SAFETY EVALUATION BY THE OFFICE OF NUCLEAR REACTOR REGULATION

APPENDIX J REVIEW

MONTICELLO NUCLEAR GENERATING PLANT

Our consultant, the Franklin Research Center (FRC), has reviewed the licensee's submittals (References 2 to 9) and prepared Technical Evaluation Report (TER-C5257-30), "Containment Leakage Rate Testing," for Monticello. We have reviewed FRC's evaluation and concur in its bases and findings, but with one exception. This exception is associated with the proposed change to Item 4.7.A.2.b.3.c of the Technical Specifications and concerns the percentage of leakage rate measured during the supplemental test during the Type A test. Further discussion of our position is stated in Section 3.3.2 of this Safety Evaluation.

Figure 1. Drywell Spray Line.

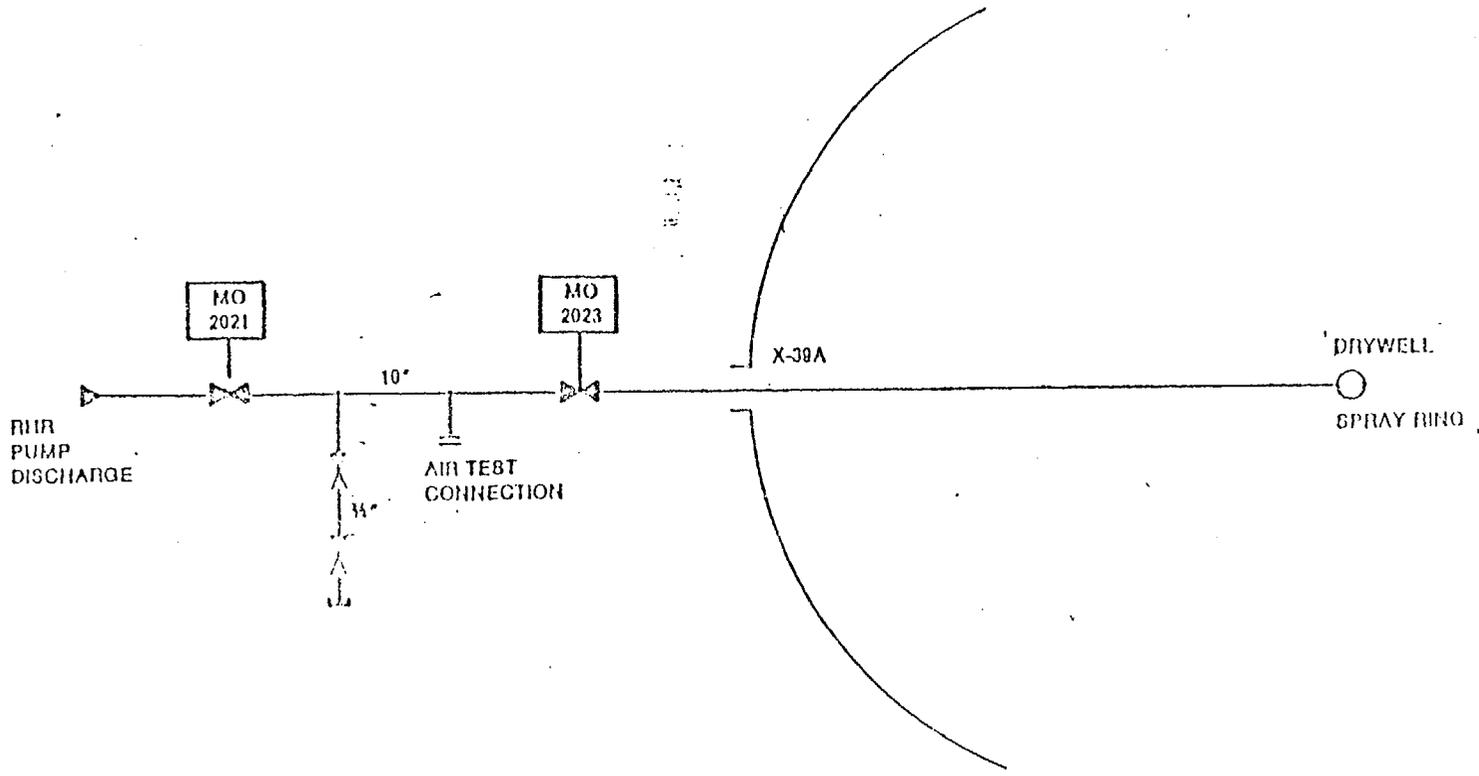
Valves MO-2021 and -2023 are normally shut valves. They are checked-shut by the safety-injection signal at the start of an accident. This is done to ensure that all low pressure injection flow is initially directed into the reactor vessel and not diverted to drywell spray. Once reactor vessel level has been reestablished, the valves receive an open-permissive signal so that the operator may initiate drywell spray to prevent excessive drywell pressure. Depending upon the extent of increase in drywell pressure, spray may or

may not be initiated. Consequently, the status of the piping between the valves (water-filled, air-filled, pressurized, etc.) cannot be conclusively stated and, for purposes of conservatism, the piping should be considered to be air-filled.

Since valve MO-2023 can become a source of leakage of containment air to the outside atmosphere, it must be Type C tested in accordance with the requirements of Appendix J. However, since the only potential sources of leakage are the packing and body-to-bonnet areas, the intent of Appendix J is satisfied if these areas are tested in accordance with Appendix J procedures. As can be seen in Figure 1, this testing can be performed by pressurizing the piping between valves MO-2021 and -2023 with air, assuming all detected leakage to be outleakage through the packing or body-to-bonnet seal.

Figure 2. Torus Spray and Recirculation Lines.

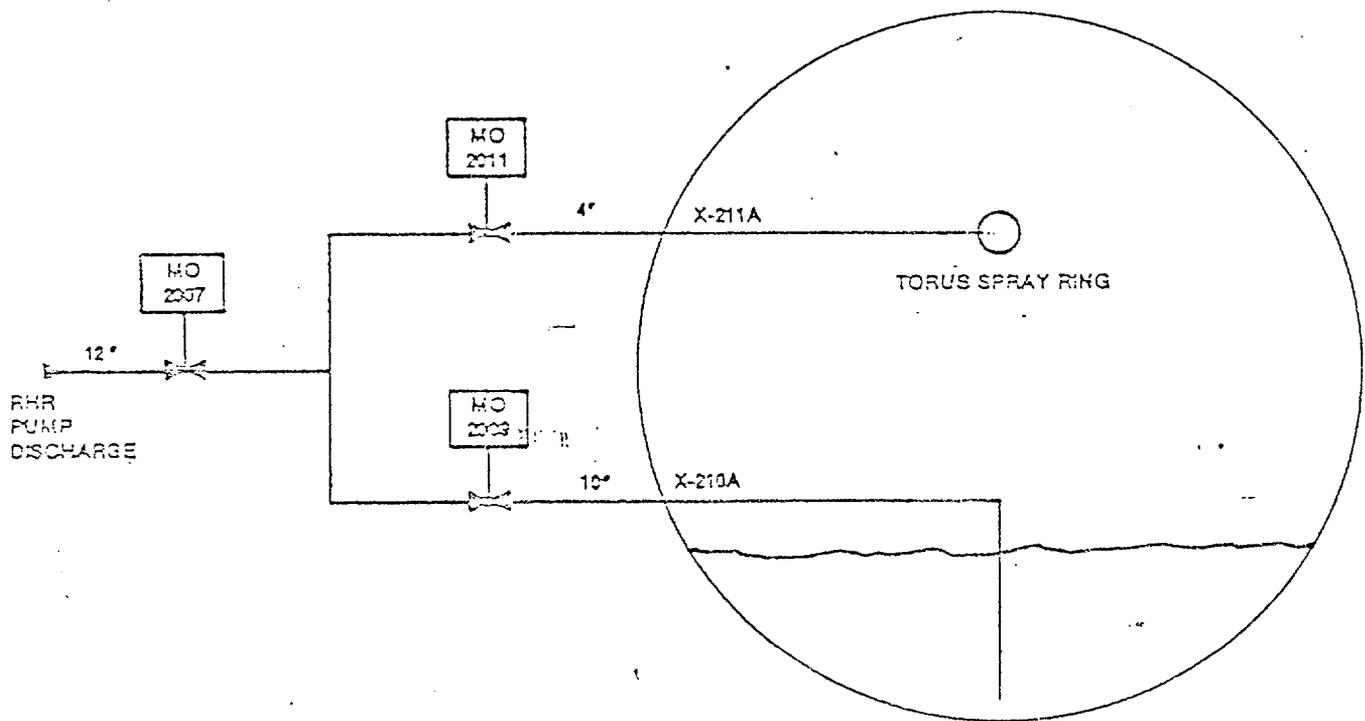
pressurized, water-filled, or air-filled (Figure 2). Unlike the drywell spray line, however, valve MO-2011 is not a single-wedge gate valve but is a globe valve. Without a detailed drawing of valve MO-2011, it cannot be determined on which side of valve MO-2011 the packing is located. Nevertheless, the basic principles involved in the discussion associated with the drywell spray line apply to the torus spray line.

As can be seen from Figure 2, it is not possible for containment atmosphere to enter the torus recirculation line because the line terminates below the water level of the suppression pool. In this case, regardless of the location of the packing of valve MO-2009, there is no potential path for leakage of containment atmosphere through the recirculation line. Consequently, valve MO-2009 is not a containment isolation valve in accordance with the definition in Section II.B of Appendix J with regard to the recirculation line. However, it should be observed that, with regard to the torus spray line, the packing of valve MO-2009 can be a potential source of atmospheric leakage if valve MO-2011 is open or leaking past its seat and the packing of valve MO-2009 is exposed to the pressure from that direction (see Figure 2).

Figure 3. Penetration X-16A.

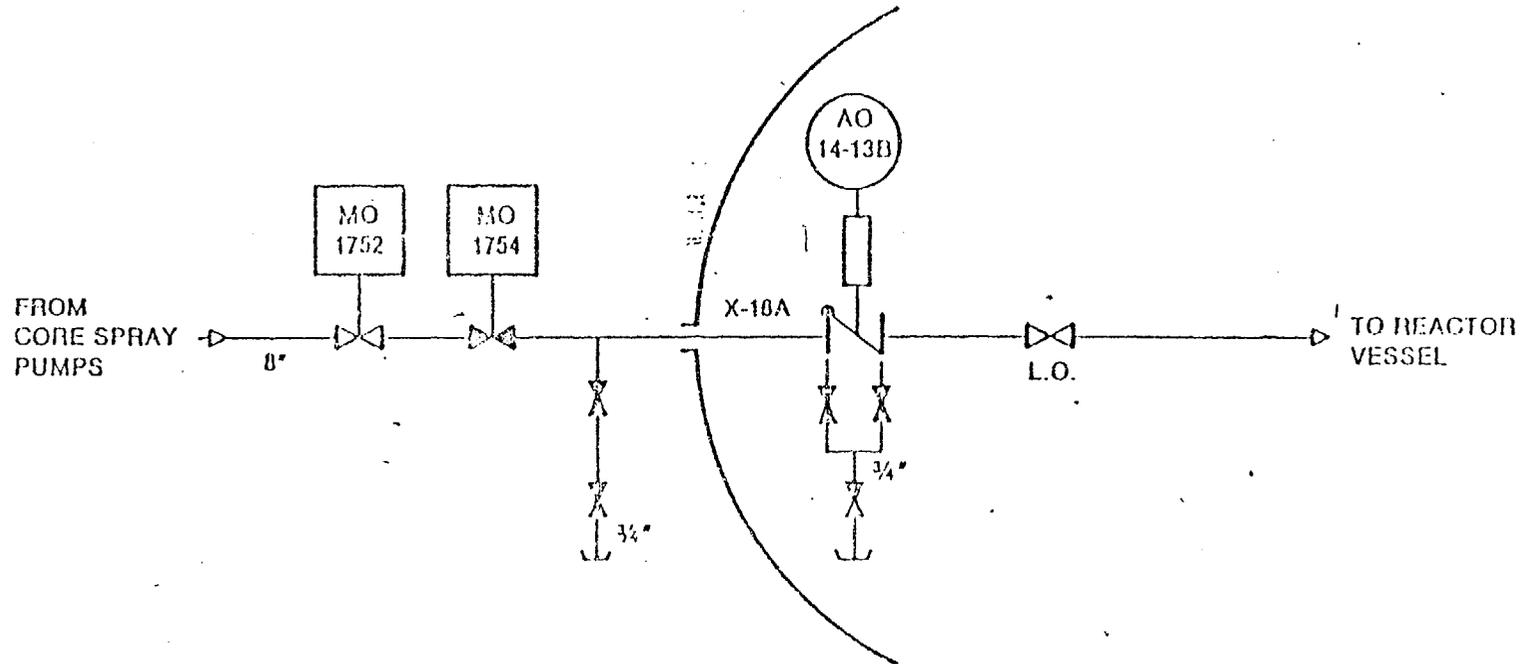
this case, there is no possibility for leakage of containment atmosphere. However, if a core spray pump fails to start, the testable check valve would be relied upon to prevent leakage of containment atmosphere if the liquid inventory of the system is exhausted by integrated system leakage before the Type C-tested motor-operated isolation valves are shut. In the case of penetration X-16A (Figure 3), valves MO-1752 and MO-1754 would have to be shut. The configuration of the other core spray penetration (X-16B) is essentially identical to the piping configuration of Figure 3.

It is concluded that the core spray testable check valves (AO-14-13A and AO-14-13B) are not relied upon to prevent the escape of containment air to the outside atmosphere. This conclusion is based on the determination that, under normal circumstances, containment outleakage is absolutely precluded by operation of the core spray system and, in the unlikely event that a core spray pump fails to start, the design features of the system and periodic inservice testing provide adequate assurance that the Type C-tested motor-operated isolation valves can be shut prior to the onset of containment atmospheric leakage.

Since the core spray testable check valves (AO-14-13A and AO-14-13B) are not called upon to perform a containment isolation function, they are not containment isolation valves as defined by Section II.B of Appendix J and do not require Type C testing. No exemption from the requirements of Appendix J is necessary. The Licensee should verify that appropriate post-accident emergency procedures require the operator to isolate an idle core spray loop by shutting the appropriate motor-operated isolation valves as soon as it is determined that there is no core spray flow and that flow cannot be established.
